Athlone Link Road Phase 2 Athlone, Co. Westmeath

Report No. RSA ST1.2 001

Stage 1/2 Combined Road Safety Audit Report

02 June 2025

3.4.3 PROBLEM

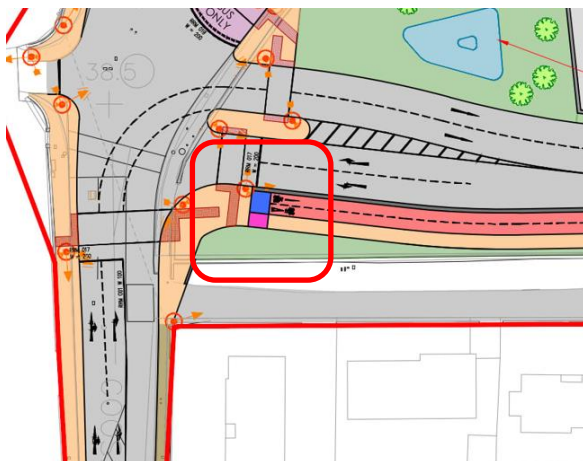
Location: Private access lane opposite St Vincent's Care Centre on Northgate Street.

Summary: Restricted visibility for vehicles emerging from private access located at or near the junction stop line.

Detail: A private access/egress is located immediately adjacent to the signalised junction stop line (on the opposite side of the carriageway), with limited visibility of approaching traffic from Coosan

Point Road. Due to the presence of signal poles, street furniture, boundary fencing, or queuing vehicles, drivers emerging from the private access may have insufficient sight distance to safely assess traffic conditions or signal phases. This could lead to vehicles exiting the access unsafely into live traffic or conflicting with vehicles approaching the stop line. The problem is exacerbated during peak periods or where access demand is high, creating an increased risk of side-impact collisions or blocking of the junction's operational area.

The location and operation of the private access should be reviewed in the context of the signalised junction layout. Where feasible, the access should be relocated or restricted to avoid direct interaction with the stop line. If relocation is not possible, mitigation measures such as improved visibility splays, controlled access (e.g. entry-only or timed operation), mirror installations, or advanced warning signage should be considered.

3.4.3	YES	YES	The existing layout of the entrance and its location, will not change in the proposed scheme, other than it will become signal controlled with an enhanced sightline to the right. This is considered to be an improvement on the existing situation, and relocation is not considered possible. Other mitigation measures will be considered as recommended by the auditor.
